Fingerboards Project EES Inquiry and Advisory Committee process

Hydrogeology and Modelling

Hugh Middlemis (expert briefed by White & Case, solicitors for Kalbar)

Conceptual Hydrogeology - Perching / CoP

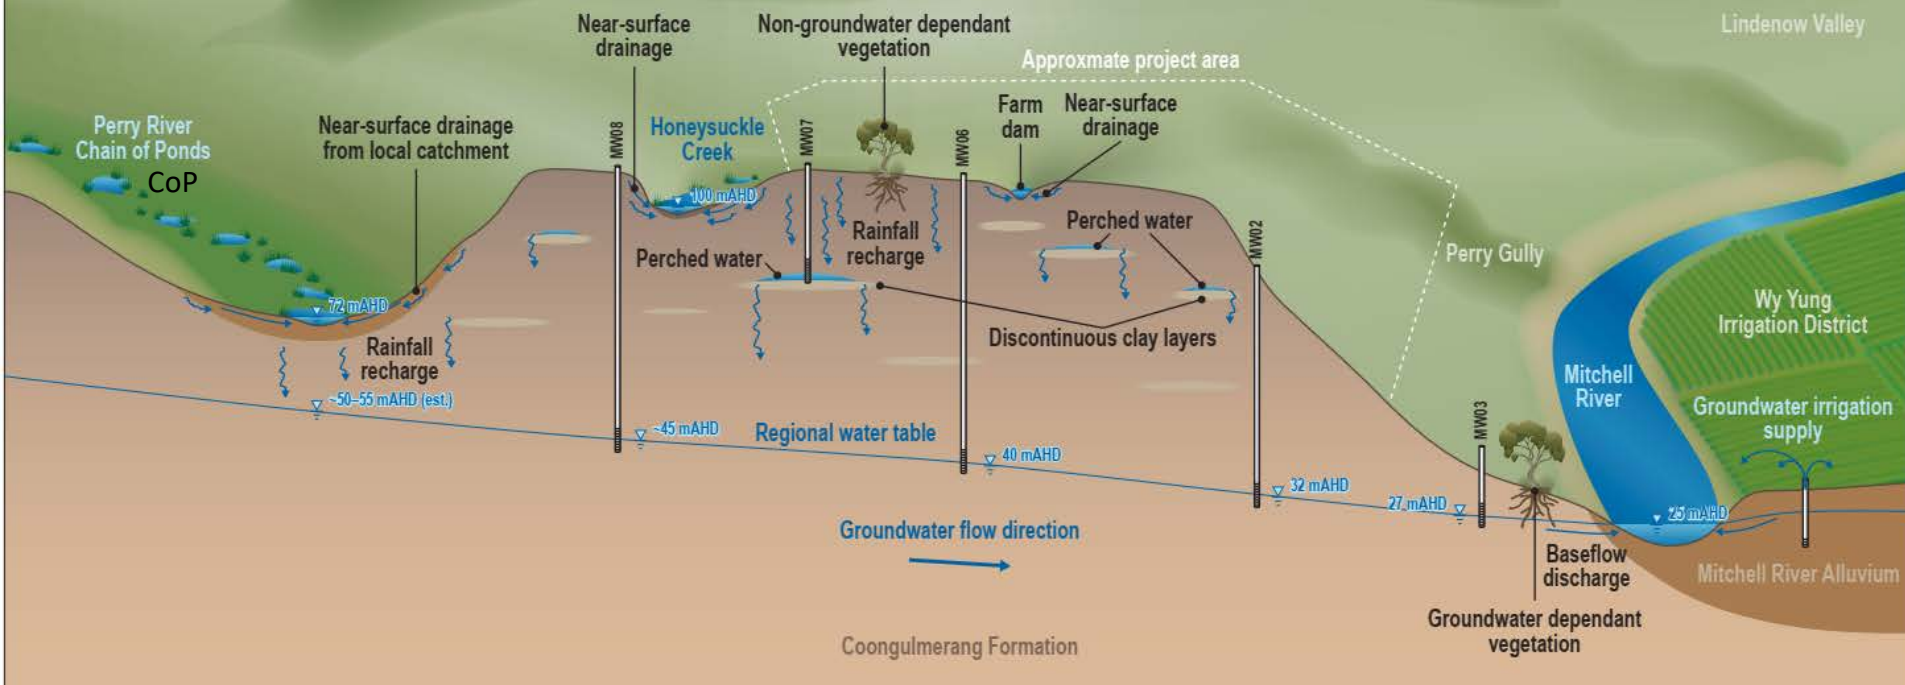
South West Conceptual Hydrogeological Model of upper Coongulmerang Formation from expert statement of John Sweeney (2 Feb. 2021), accepted at groundwater conclave, shows: North East

- Mitchell River, alluvium and associated groundwater dependent vegetation, which receive groundwater baseflow from regional water table;
- Perched units (discontinuous) and Chain of Ponds (CoP) are above regional water table.

Drawdown cannot affect features above the regional water table (CoP and perched).

Mounding on discontinuous perched units drains at edges, so very unlikely to reach up to surface. As perching units are discontinuous, no causal pathway for mounding impacts to CoP, but some potential for local effects in Perry Gully area and/or Honeysuckle Creek areas.
